Technical News Bulletin

December, 2007

FPS for Plunger Up - Performance Enhancement

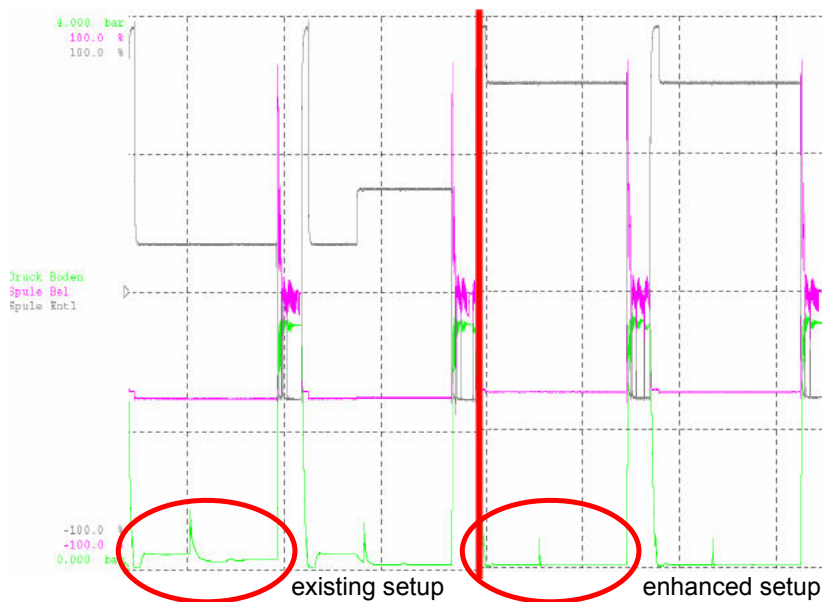
The performance in the Blow and Blow process as well as in Narrow Neck Press and Blow could be significantly improved due to optimized FPS valve parameter settings. This has been possible because of the features the new designed valves which introduced earlier this year (see TNB 122) provide.

In Blow and Blow production the significant difference is the motion from the Counter Blow Position to the Down Position. The speed of the plunger movement from the **Counter Blow Position to the Down Position** will be much faster and more controllable as on the previous setup.

The motion from the **Down Position into the Up Position** and the motion from the **Up Position to the Counter Blow Position** will not be affected by the changes.

2.2 Narrow Neck Press and Blow/Press and Blow Production

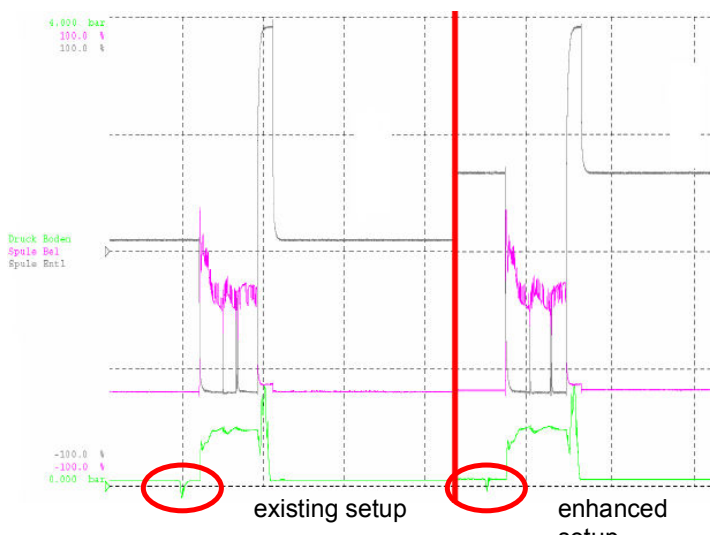
In Narrow Neck Press and Blow as well as Press and Blow the significant difference is the motion from the **Down Position to Loading Position**. The motion speed to the loading position and the precision of the loading position will be enhanced with the new setup. The **Pressing** and the **Down Motion** will remain unchanged.
